# Building Permit Application

RE: B18003067 / 6517 Heather Glen Way, Clarksville 21029  
Amend Permit to include Partially Finished Basement

RE: 6517 Heather Glen Way  
Clarksville, MD 21029  
***Potential Basement Bedroom***

**PLOT PLAN**  
**WILLOW POND - LOT 9**  
6517 HEATHER GLEN WAY  
CLARKSVILLE, MD 21029  
REF: F-10-106

PROPOSED BASEMENT PLAN  
SCALE: 1/4" = 1'-0"

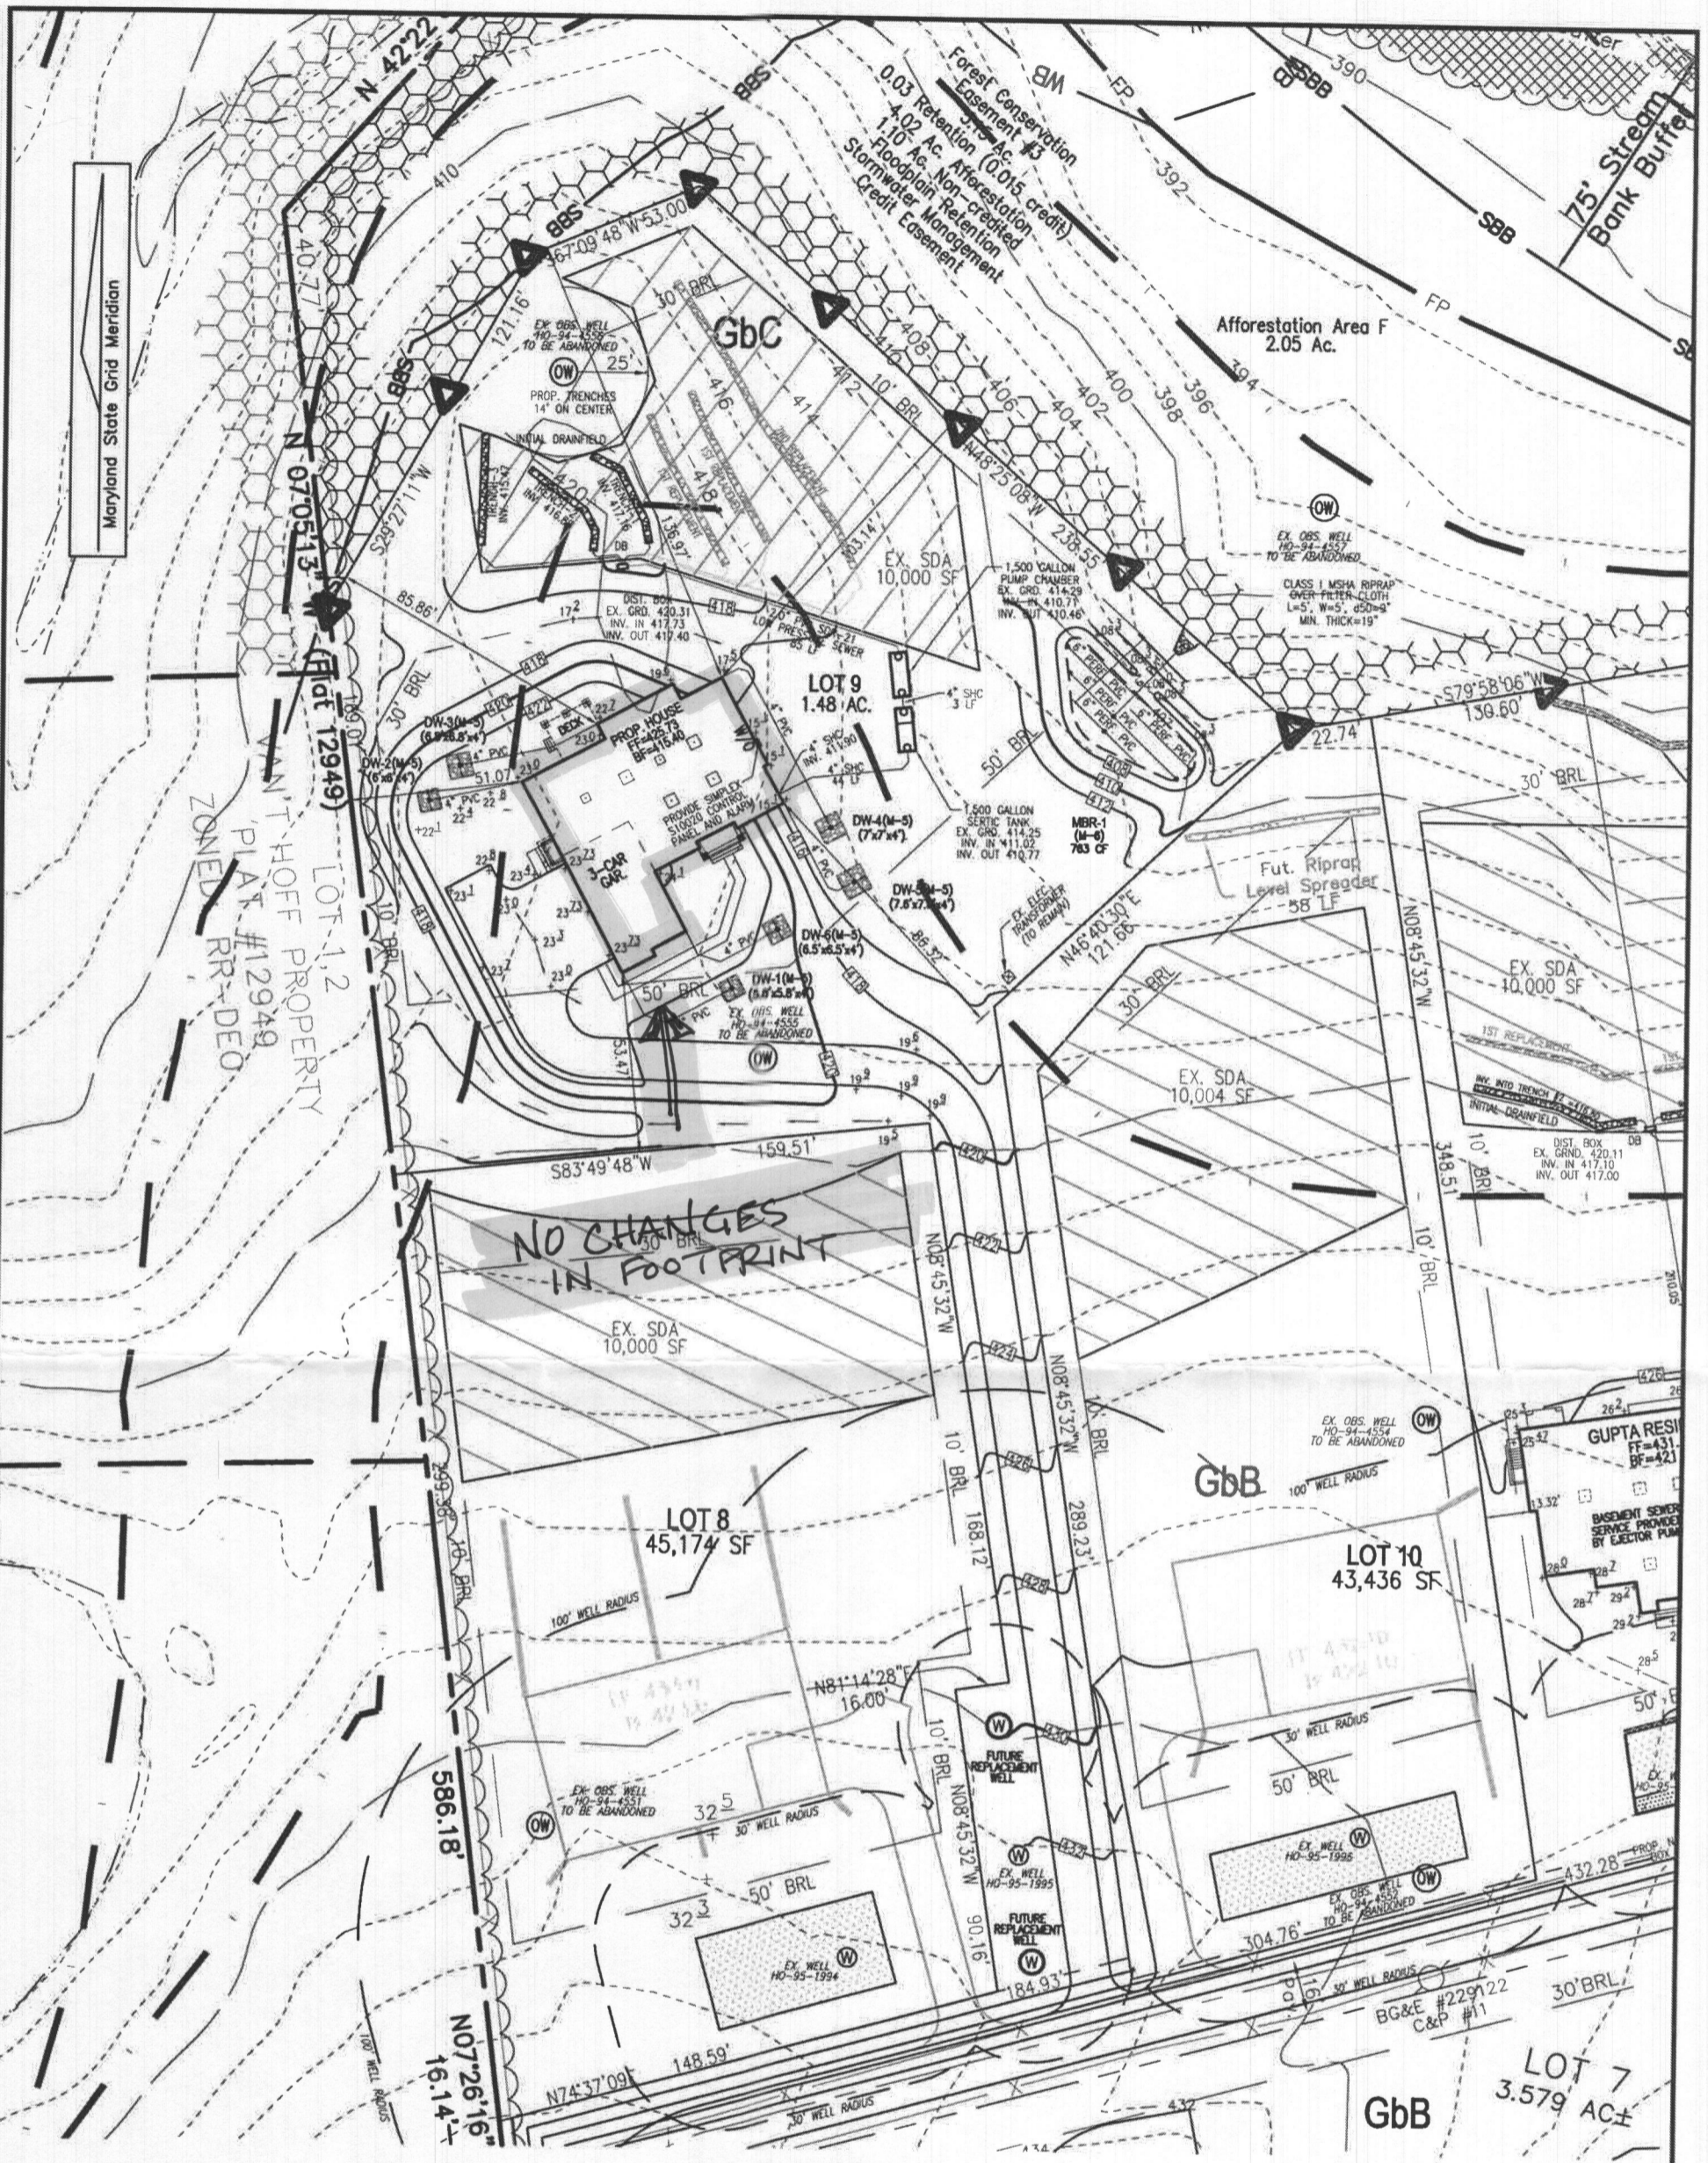
This is Rick Minor with Greenfield Homes, requesting to amend the building permit to partially finish the basement.

The finished area includes:  
Approximately 1,173 square feet  
1 Powder Room  
1 Full Bath  
1 Recreation Room  
1 Bedroom with Walk In Closet

The exterior footprint remains the same  
There are no additional windows or doors added, all windows and doors are from original construction with egress windows in bedroom and patio door in rec. room

WINDOWS & PATIO  
DOOR FROM ORIGINAL  
CONSTRUCTION

AREA TO BE FINISHED  
APPROX. 1173 SF.

**FOUNDATION PLAN**  
SCALE: 1/4" = 1'-0"

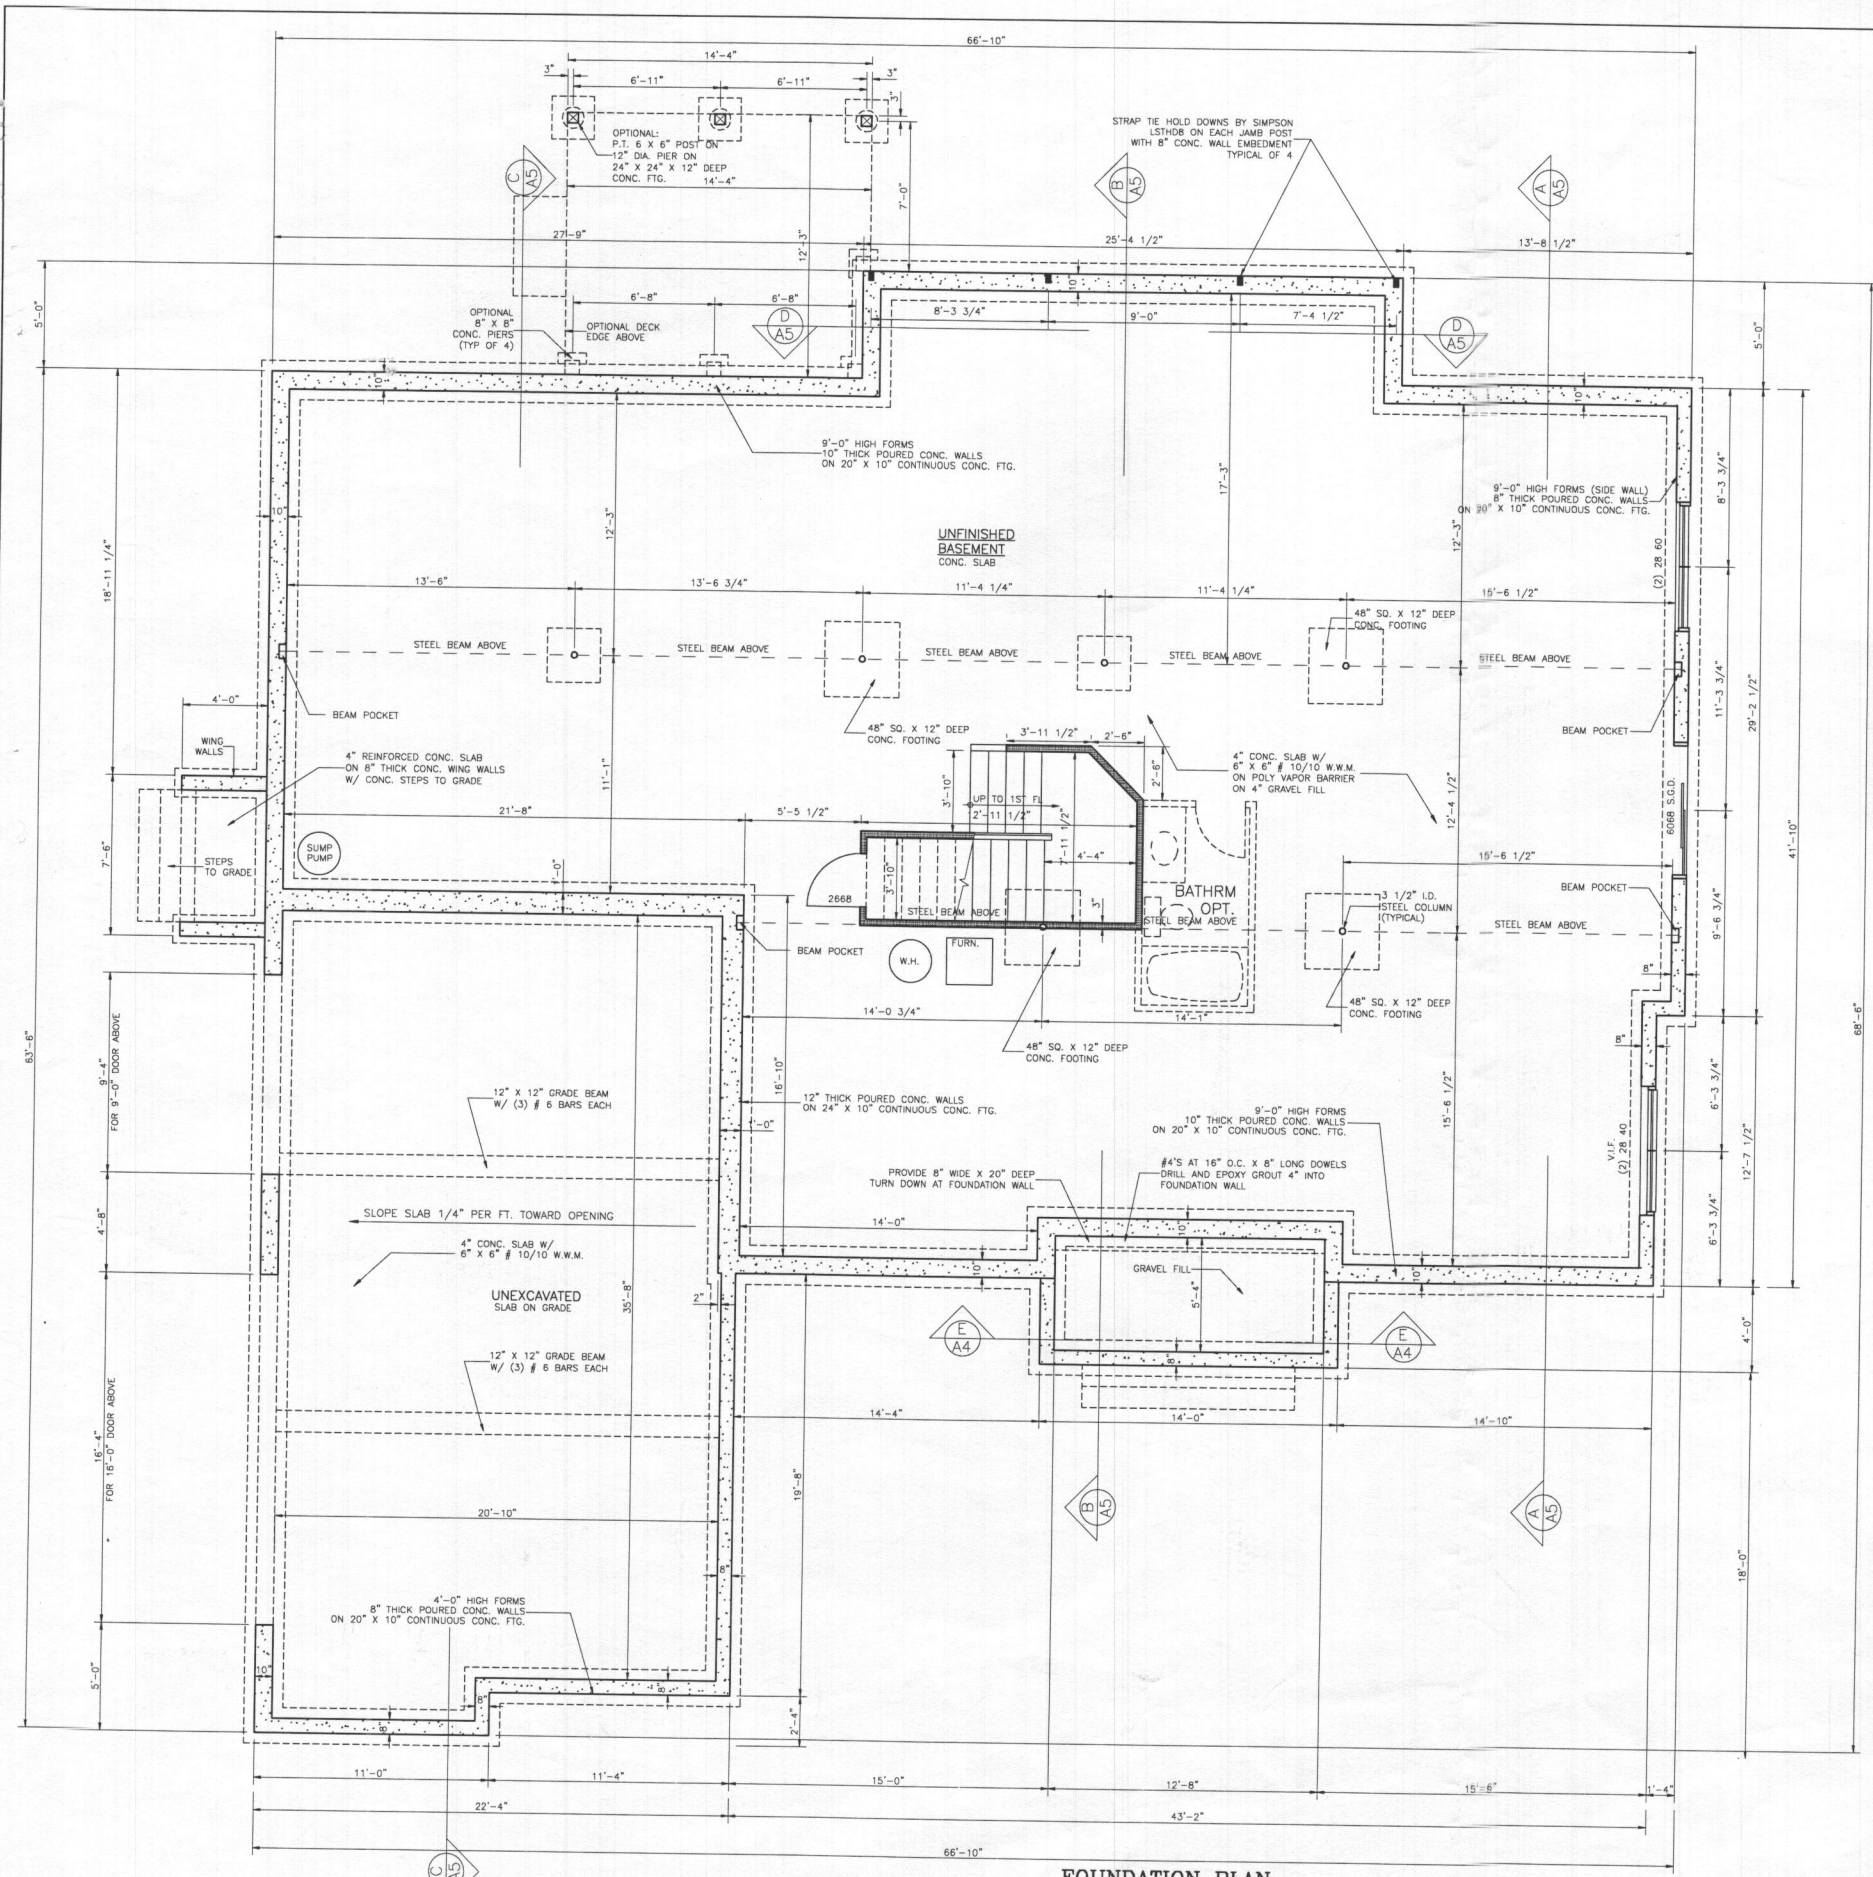
I have reviewed the floor plans in support of Building Permit B18003067 for a new home at 6517 Heather Glen Way and noted that there is a rough-in for a full bathroom in the unfinished basement. Please note that this makes it very likely for one or more rooms to be considered bedrooms upon conversion of the basement to finished living space.

The Health Department strongly recommends sizing the onsite sewage disposal system at least one bedroom larger than the existing 5 bedroom design to accommodate a future finished basement. If you choose to only size for the existing design, any future building permit for a finished basement may be

placed on hold until the system is upgraded to accommodate the proposed number of bedrooms. This memo will be retained in the Health Department file for future reference.
